Naser Jaber with GIT Homes
25-005329-ZBA
618 Montgomery St
February 26, 2026

Proposed Subdivision for 618 Montgomery St

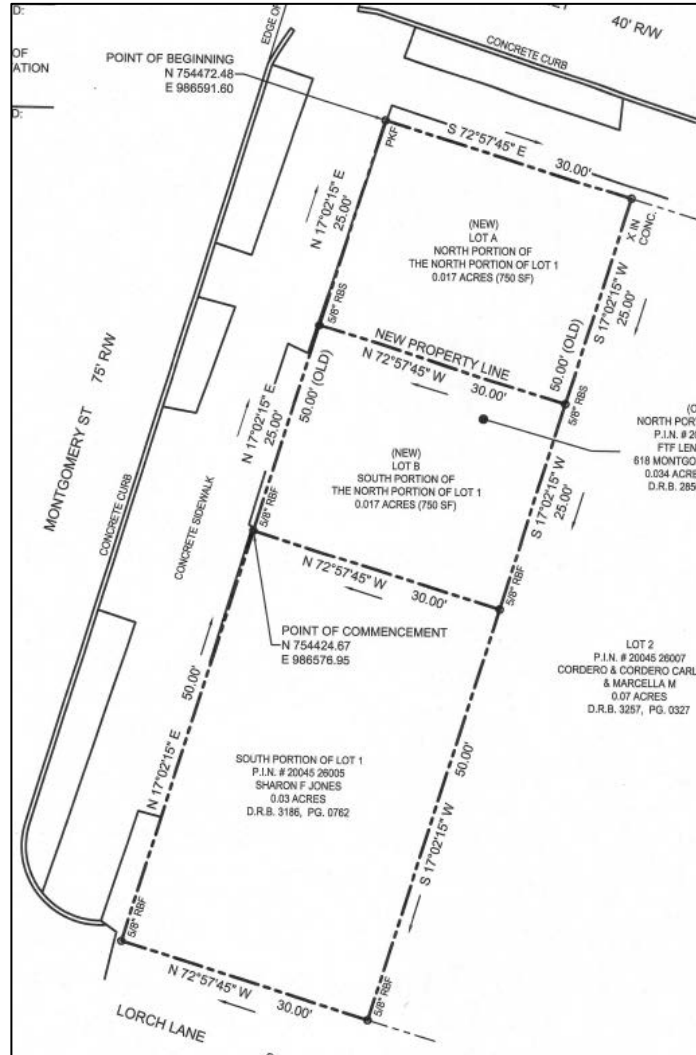
MPC Comment: The Traffic Engineering department has determined that no off-street parking or driveway access is permitted on the parcel. This condition would present a hardship if the Petitioner were proposing development for a single-family dwelling alone. However, the Petitioner is proposing to subdivide the lot and construct two townhouses, which increases the required off-street parking demand.

MPC Comment: The hardship stems primarily from the Petitioner's proposal to subdivide the property and develop two townhouses, which increases the off-street parking requirement. While the inability to provide off-street parking due to Traffic Engineering constraints could present a hardship if the lot were developed with a single-family dwelling, the expanded request for two townhouses increases the extent of the relief being sought. Because that design choice is a result of the Petitioner's actions rather than a unique physical condition of the property, the hardship is largely self-inflicted.

MPC Comment: The variance is not required to make use of the subject property with the proposed design. However, the variance relief for one off-street parking space would be required if a single-family dwelling were proposed instead.

MPC Staff recommends **denial** of the requested variance for relief from two off-street parking spaces in association with a subdivision of one lot into two lots for the development of two townhouses in the D-C zoning district.

Alternatively, if the Petitioner were proposing a single-family dwelling on the lot without subdivision, the lack of permitted ingress/egress could create a hardship that would support approval of a variance for relief from **one** off-street parking space.
